## Service Tip

***Problem:*** Poor response of AV Receiver to remote commands.

***Solution:*** Change HTR-1 IR transmission frequency.

Diagram 1

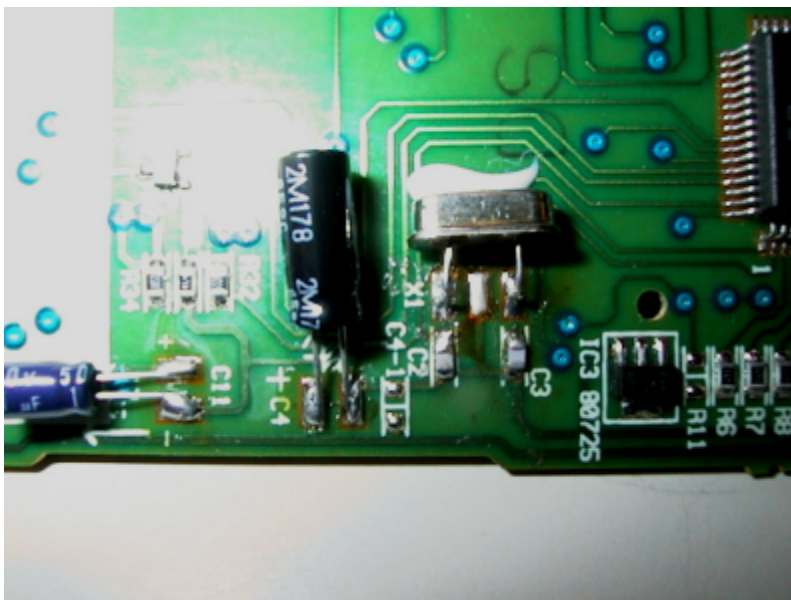
1. Open the case of the HTR-1 by using only a thin but strong plastic screwdriver or similar tool (metallic tool will damage case). There are 5 tabs on each side of the remote that hold it together. Start at the top of the remote on either the right or left side. Locate the slot that runs along the side of the remote. By inserting and pressing the screwdriver down on an angle towards the bottom part of the case the tab should release. Work your way down the remote releasing the tabs and the case will open up. See Diagram 1 for reference.
